Proposal for Supplement 3 to the original text to UN Regulation No. 152 (Advanced Emergency Braking Systems for M₁ and N₁ vehicles)

Submitted by the experts from the Informal Working Group on Advanced Emergency Braking Systems for vehicles of Categories M₁ and N₁**

Figure 1: LEFT TURN OR RIGHT TURN AT THE INTERSECTION

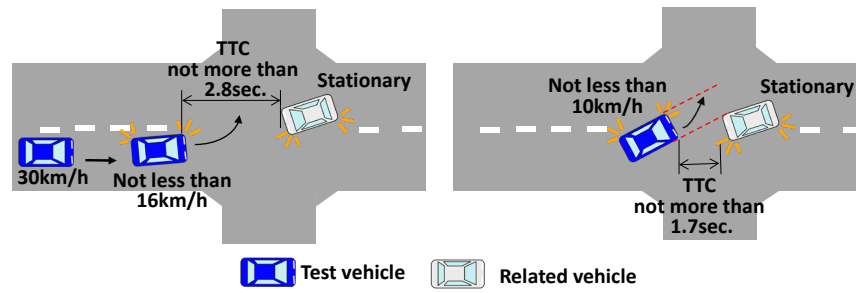
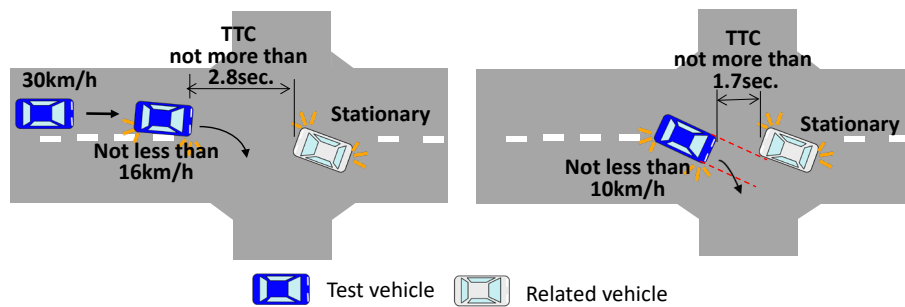
The TTC to the oncoming vehicle is not more than 1.7 seconds at when the ~~wrap~~ **overlap** ratio between the subject vehicle and the oncoming vehicle becomes 0%.

- 1) Beginning to steer for left turn 2) **Overlap** ratio 0%

- 1) Beginning to steer for right turn 2) **Overlap** ratio 0%

Change of “wrap ratio” into “overlap ratio” and introduction of a definition of “overlap ratio”. The proposed drawings are improved accordingly.

Figure 2: right turn or left turn of a forward vehicle

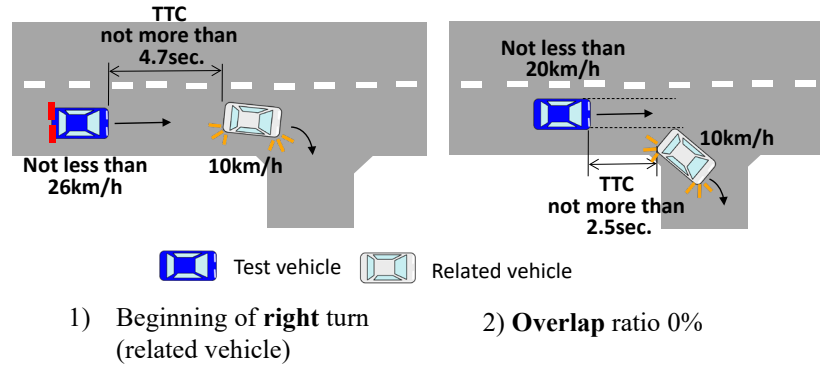
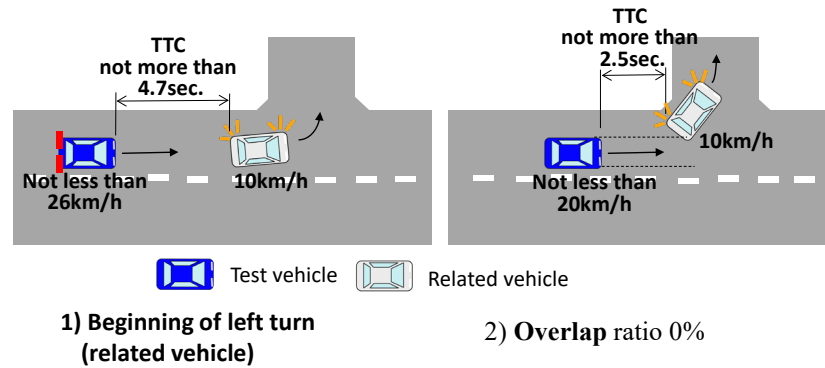
The TTC to the forward vehicle is not more than 2.5 seconds at when the ~~wrap~~ **overlap** ratio between the subject vehicle and the forward vehicle becomes 0%.”
